**PROPOSED DEVELOPMENT
LADY'S LANE, LIMERICK**

Road Safety Audit Stage 1/2

Project Title	Proposed Development at Lady's Lane, Limerick
Project No.	26125-01
Document Title	Road Safety Audit Stage 1/2
Document No.	26125-01-001

Figure 2.1 – Cyclists' Access

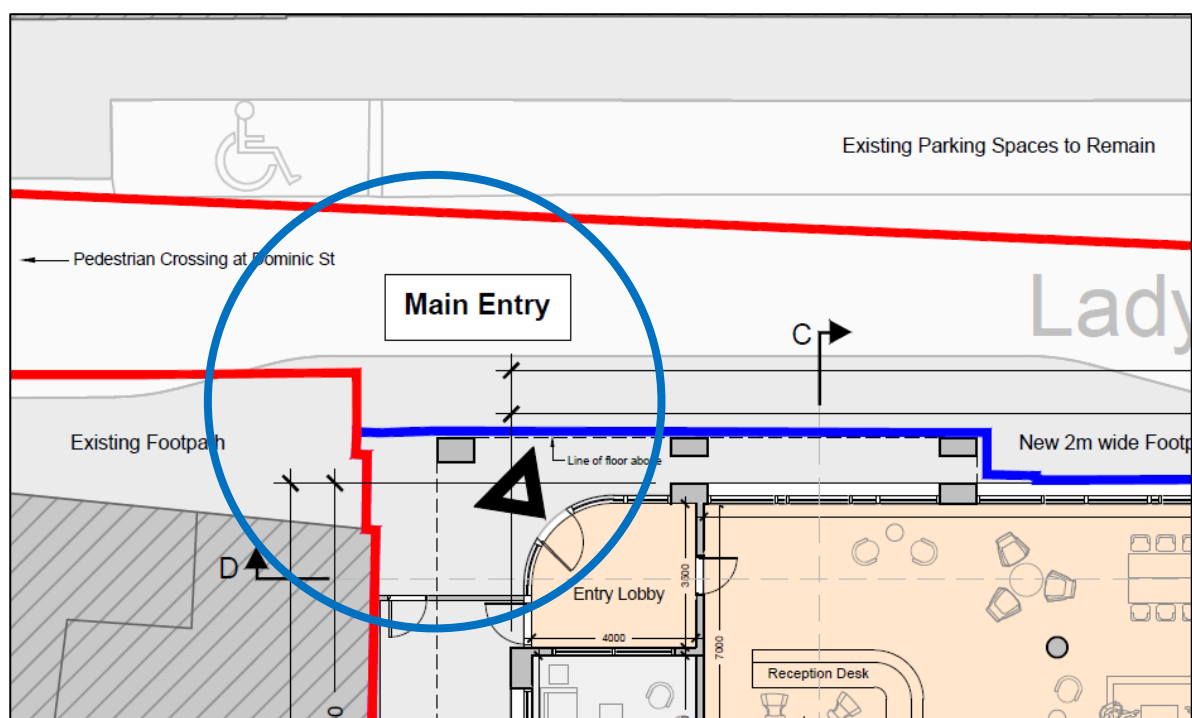
2.1 Problem: Cyclists' Access to the Storage Facility

It is unclear how cyclists approaching from Lady's Lane will access the proposed cycle storage area within the development. A full-height kerb exists at the interface between Lady's Lane and the footpath, and cyclists are required to cross a pedestrian footway to reach the cycle storage area. No dedicated cyclist access route is indicated on the drawings. This arrangement may result in conflict between cyclists and pedestrians, increasing the potential for collisions and reducing the safe and convenient use of the cycle parking facilities.

Recommendation: Provide a clearly defined and accessible cyclist route between Lady's Lane and the proposed cycle storage area. This should include an appropriate crossing point with a dropped kerb and tactile paving where required, together with a dedicated access arrangement that minimises conflict with pedestrians. The design should demonstrate that cyclists can safely and conveniently access the cycle storage area without the need to traverse pedestrian-only areas

Figure 2.2 – Obstructed Visibility

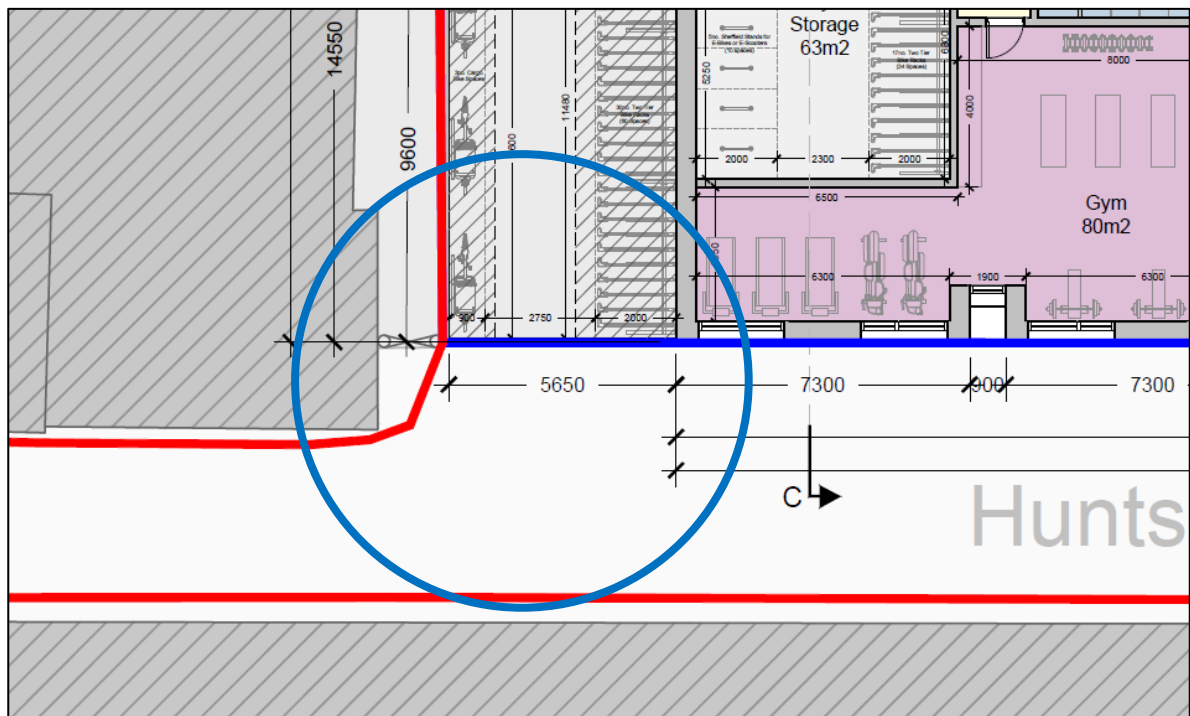
2.2 Problem: Inadequate Intervisibility

It is unclear whether cyclists can access Hunts Lane from the proposed cycle storage facilities. If allowed the visibility splay to the right from the proposed access from the bicycle storage is partially obstructed by adjacent buildings. The risk of collision is increased in situations where inter-visibility between cyclists and approaching drivers is restricted.

Recommendation: Ensure adequate intervisibility is provided between cyclists and drivers of vehicles approaching at this location.

Figure 2.3 – Narrow Carriageway

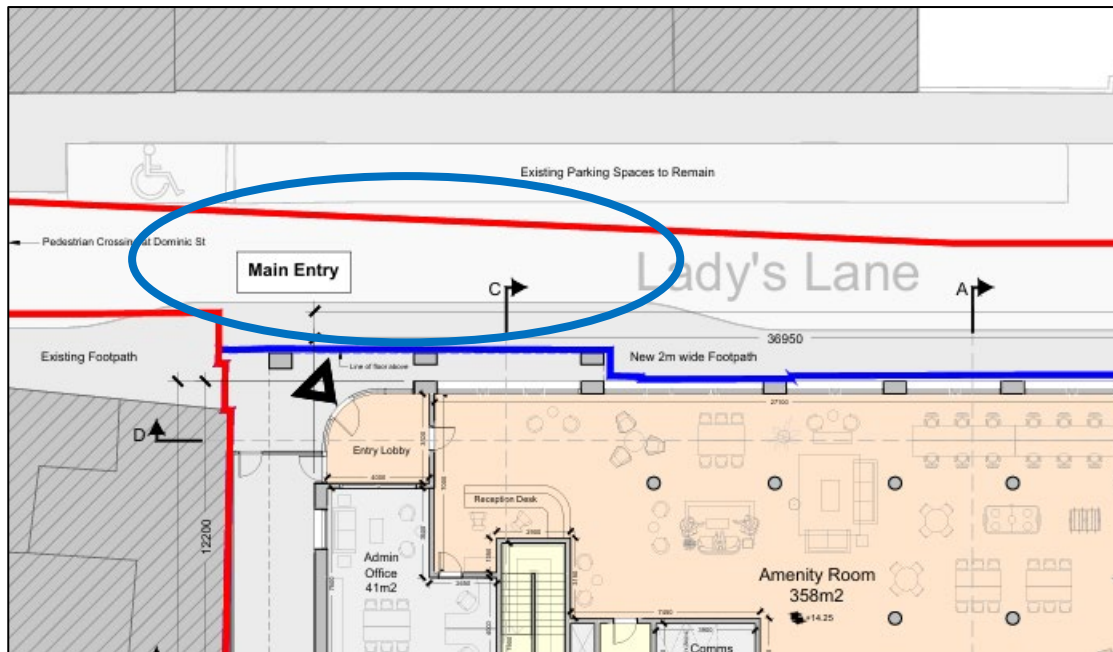
2.3 **Problem:** Carriageway Width

Footpath widening is proposed along Lady's Lane, resulting in a reduction of the carriageway width to approximately 4.0 m. The reduced width is unlikely to accommodate two-way vehicular movements. In the absence of appropriate traffic management or priority control measures, opposing vehicles may attempt to pass simultaneously, leading to conflicts, sudden braking, reversing manoeuvres, or encroachment onto pedestrian facilities. This may lead to vehicles overrunning the adjacent footpath or undertaking inappropriate manoeuvres to pass one another, increasing the potential for conflict with pedestrians, cyclists and opposing vehicles.

Recommendation: Provide appropriate measures to manage vehicular movements along the narrowed section of Lady's Lane such as a priority working arrangement.

Figure 2.4 – Upstand Kerbs at Pedestrian Crossing

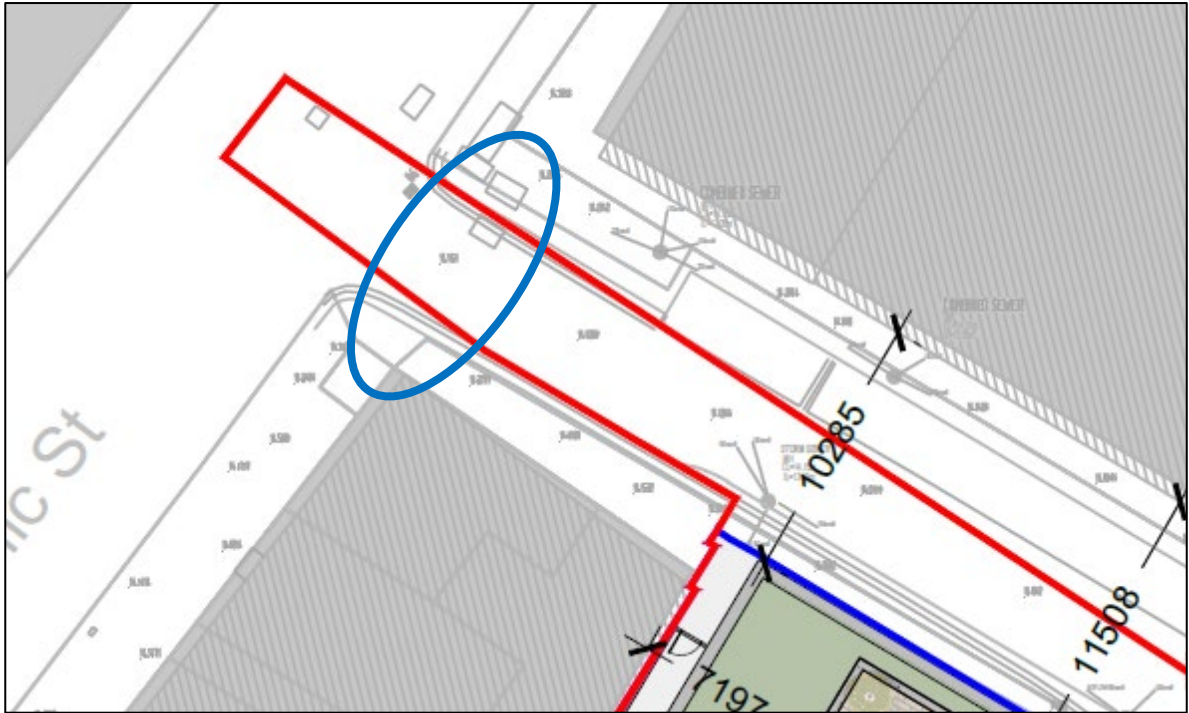
2. 4 Problem: Uprand Kerb at Pedestrian Crossing

Uprand kerbs were observed at the existing crossing location, where pedestrians are likely to seek access to the footpaths. The drawings do not appear to include dropped kerbs or tactile paving at this location. This may increase the risk of trips and falls where pedestrians attempt to access the footpaths without suitable dropped kerbs and tactile paving provision.

Recommendation: Proposed kerb layout should be reviewed and modifications implemented to ensure dropped kerbs and tactile paving for pedestrian access is provided at locations where pedestrian access/use is anticipated.

Figure 2.5 – Pedestrian Crossing

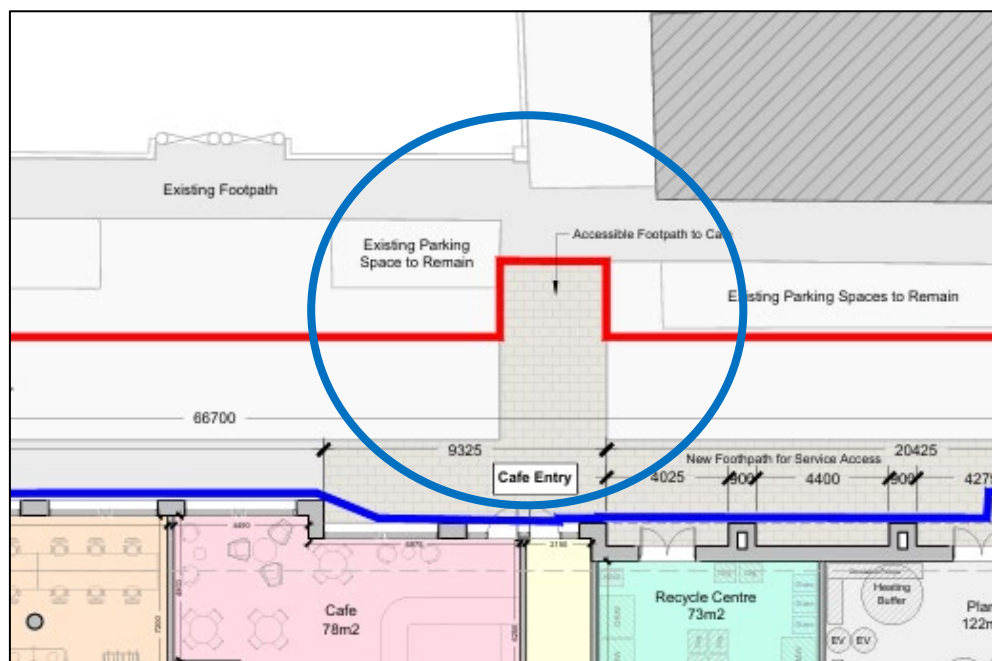
2.5 Problem: Pedestrian Crossing

A pedestrian crossing is proposed across Lady's Lane adjacent to the access serving the proposed Café. The following issues have been identified with the proposed arrangement:

- The type of crossing proposed is unclear from the submitted drawings and it is not evident whether the crossing is intended to be controlled or uncontrolled.
- No tactile paving has been provided at the crossing location to assist visually impaired pedestrians.
- The crossing is located at the shared access to Parnell Arcade, where vehicles are likely to enter and exit.
- The crossing is also located within an area likely to be used by vehicles undertaking turning manoeuvres at the end of Lady's Lane.
- Intervisibility between pedestrians using the crossing and drivers approaching the crossing may be restricted by vehicles parked in the adjacent parking space.

The combination of pedestrian crossing movements, vehicle access movements and vehicle turning manoeuvres at the same location may create uncertainty regarding priority and increase the potential for pedestrian-vehicle conflicts. Restricted visibility caused by parked vehicles may further reduce drivers' ability to detect pedestrians in sufficient time to react, increasing the risk of collisions. The absence of tactile paving may also reduce the accessibility and conspicuity of the crossing for visually impaired pedestrians.

Recommendation: Review the location and design of the proposed pedestrian crossing. The crossing type, location and associated priority arrangements should be clearly defined and should demonstrate that pedestrian movements can be accommodated safely, conveniently and with appropriate visibility.

Figure 2.6 – Turning Area

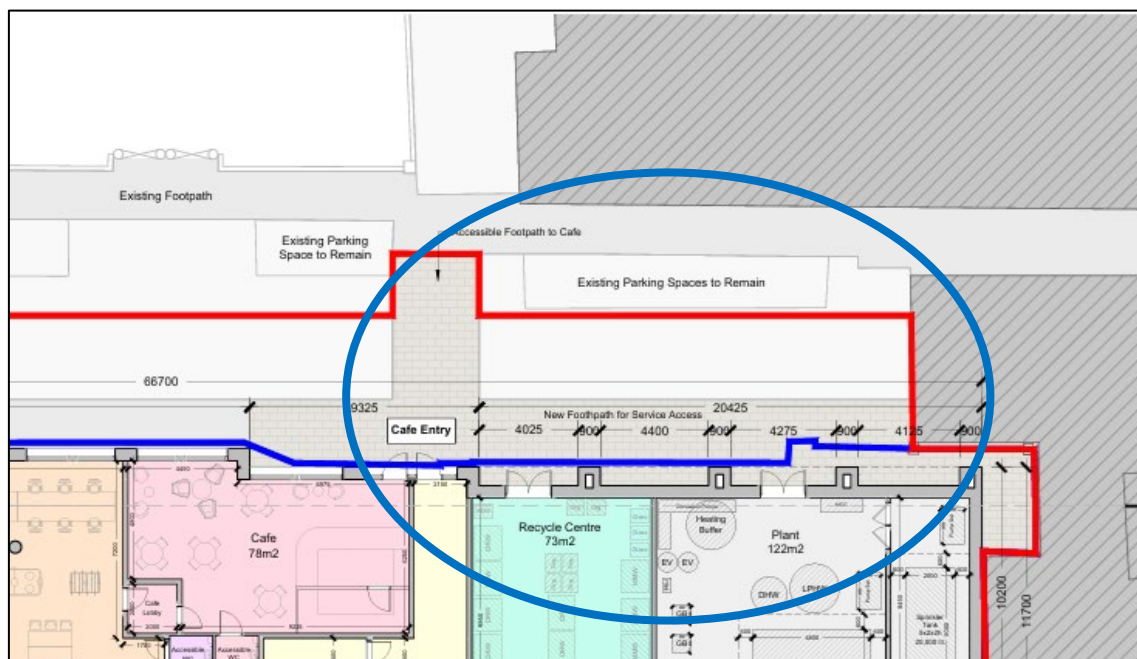
2.6 Problem: Turning Area

A recycling centre and plant room are proposed at the end of Lady's Lane. It is anticipated that these facilities will require access by refuse collection vehicles and other service vehicles. However, it is unclear whether adequate turning facilities are available to enable such vehicles to enter and exit in a forward gear. In the absence of a suitable turning area, service vehicles may be required to reverse for a significant distance along Lady's Lane. Reversing manoeuvres over extended distances increase the potential for conflicts with pedestrians, cyclists and other vehicles using the lane. Drivers may have limited visibility of vulnerable road users, particularly where pedestrian activity associated with the proposed development is expected. This may increase the risk of collisions at this location.

Recommendation: Ensure that an adequate turning area is provided to cater for all anticipated vehicles turning at the end of Lady's Lane.
